AMENDMENTS TO THE DRAWINGS

"REPLACEMENT SHEET"

FIG. 1
CONVENTIONAL ART

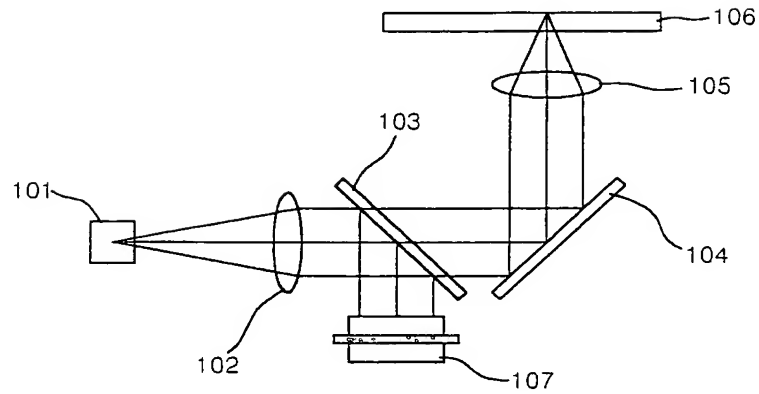
In Figure 1, the label “Conventional Art” was added; and in Figure 2, the letters “HPM” were added to the front-end of light source 201.
